**IN THE MATTER:** Proposed Plan Change 2: Pukehangi  
Heights to the Rotorua District Plan under  
Part 5, Sub-Part 5 – Streamlined Planning  
Process and Schedule 1 Part 5 of the  
RMA

**SUMMARY STATEMENT OF EVIDENCE OF PETER MORLEY WESTON BEHALF OF BAY  
OF PLENTY REGIONAL COUNCIL – HYDROLOGICAL BASIS FOR ANALYSIS**  
21 September 2020

Figure 1: Hydrological model results for Utuhina Stream at the Depot Street gauge. Showing results for the 1% AEP (100 year) 72 hour nested storm centred on the PC2 plan change location, travelling on a bearing due north at 2 metres per second.

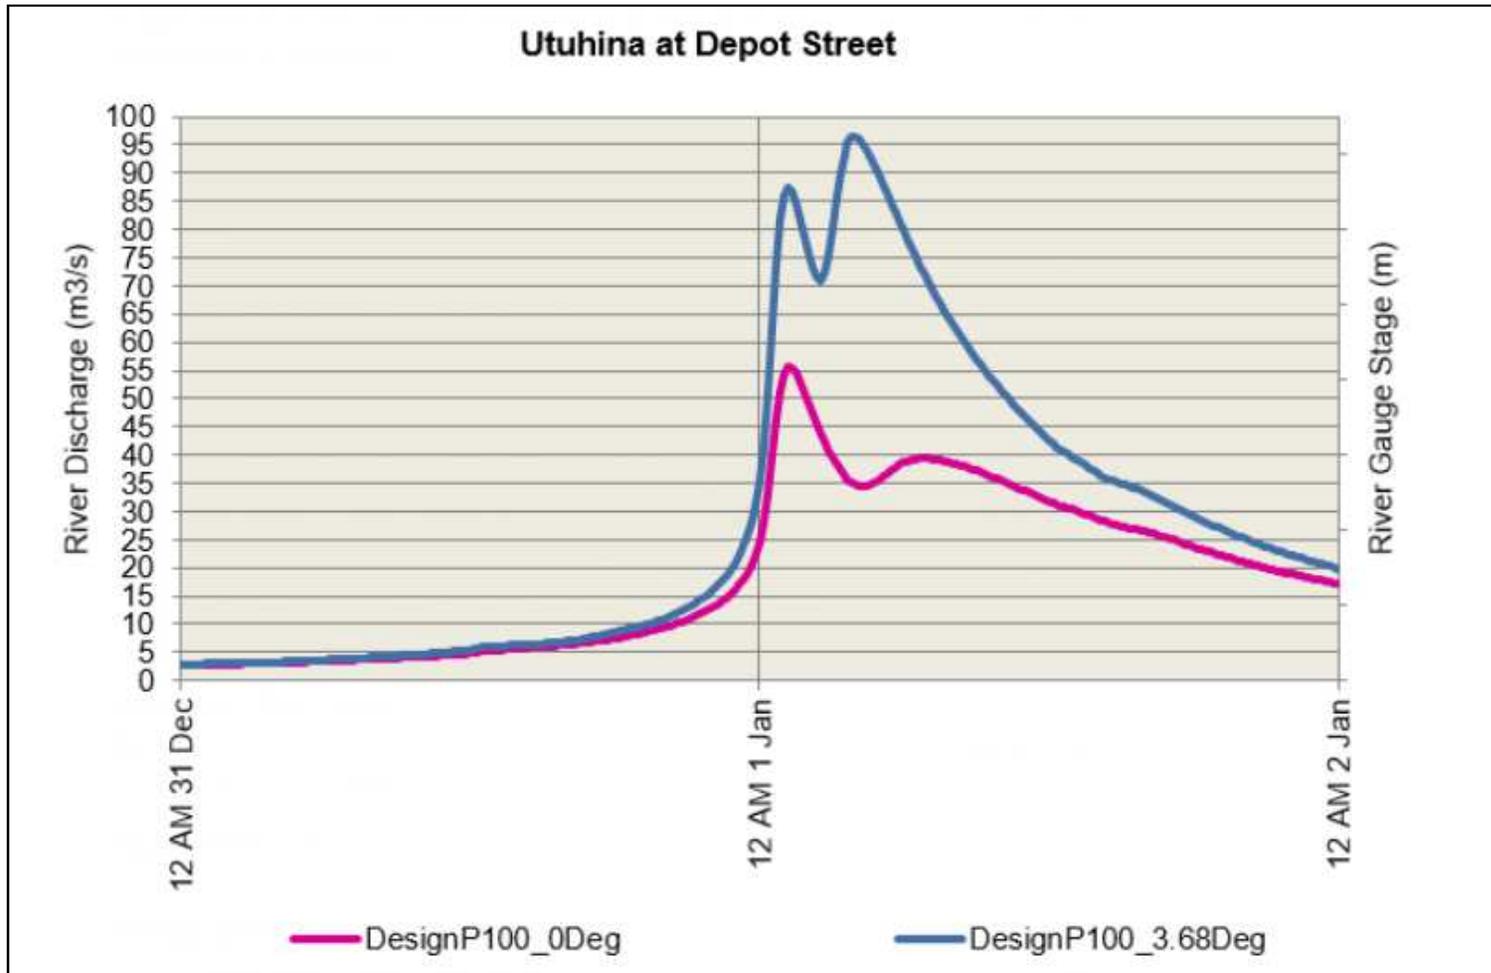
6. One item of key importance in this part of my evidence: (paragraph 17 in main brief) **Figure 1** shows the model discharge results at the location of the Utuhina stream recorder at Depot Street for the 1%AEP current climate and 1%AEP 3.68 degrees climate scenario. The figure illustrates the potential increase in flood flow that can be

expected over the next 100 years. This is an increase of from about 55 m<sup>3</sup>/s to up to 95 m<sup>3</sup>/s.
